# Appendix "B"

## NCDENR Technical Comments

**State-Level Coal-Fired Gross Heat Rate Calculated from EPA AMPD Data**

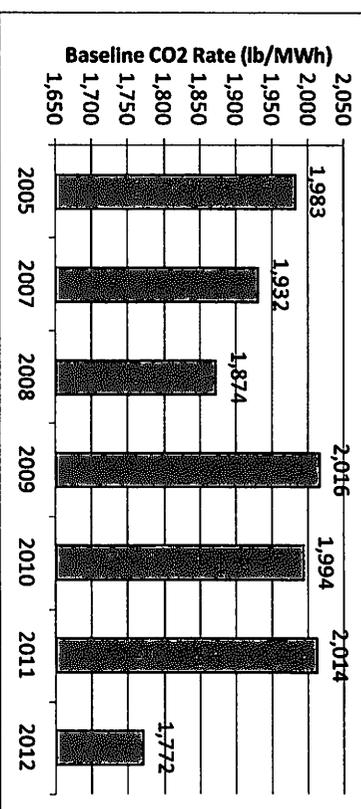
2. Since EPA did not provide the data for individual EGUs analyzed in its statistical approach, we were unable to discern where North Carolina's fleet ranked relative to others. To assess the relative performance of our coal fleet, we calculated the state-level gross heat rate using EPA AMPD data for year 2012. We found that North Carolina's 2012 gross heat rate for coal-fired EGUs was 9,071 Btu/kWh, which is significantly lower than EPA's national average of 9,753 Btu/kWh and the lowest in the country. North Carolina's heat rate performance results are before making corrections that EPA made to account for variability in meteorology and capacity factors, and would most likely be lower when these factors are accounted for. The table below shows the comparisons.

Having the lowest gross heat rate reflects that some or most of North Carolina's coal-fired EGUs have successfully implemented efficiency measures prior to the proposed rule making. North Carolina's heat rate values can be correlated with the actions taken by the state legislature with the enactment of the Clean Smokestacks Act in 2002 which required significant reductions in NOx and SO2 emissions from coal-fired EGUs. Compliance with the law resulted in multiple retirements, natural gas conversions, and add-on pollution control equipment, with 2013 being the final compliance year for meeting emissions targets.
